Product / Process Change Notification (PCN)

PCN #: PCN_UtRJ45LAN_20211203

Affected Series: WE-RJ45LAN; 7499xxx

DESCRIPTION AND PURPOSE OF CHANGE:

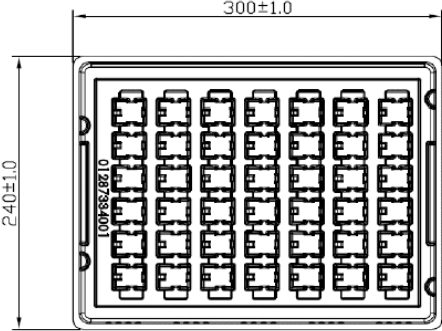
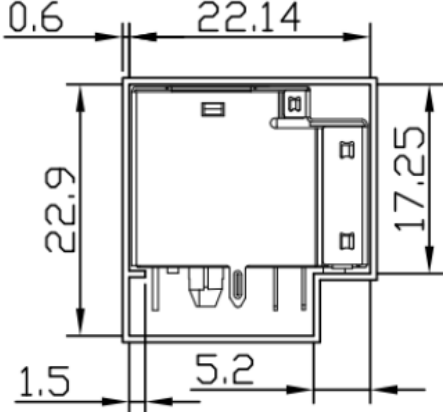
For improved handling of articles in warehouse, Würth Elektronik will optimize the carton size and quantity, tube form and quantity and the orientation of the articles in the tubes. Please see details below:

Before Change	After Change	Affected articles
Carton: 567*130*120 mm	Carton: 550*265*165mm	All articles of PCN
<p>Tube: 23 pcs Carton: 460 pcs</p>	<p>Tube: 32 pcs Carton: 1920 pcs</p>	7499012000

<p>Tube: 23 pcs Carton: 460 pcs</p>	<p>Tube: 31 pcs Carton: 1860 pcs</p>	<p>7499010213 7499210121</p>
<p>Tube: 23 pcs Carton: 460 pcs</p>	<p>Tube: 29 pcs Carton: 1740 pcs</p>	<p>74990110013 7499011121 74990111215 74990112120 7499011215 7499111213 7499111443</p>
<p>Tube: 20 pcs Carton: 400 pcs</p>	<p>Tube: 30 pcs Carton: 1620 pcs</p>	<p>7499012121</p>
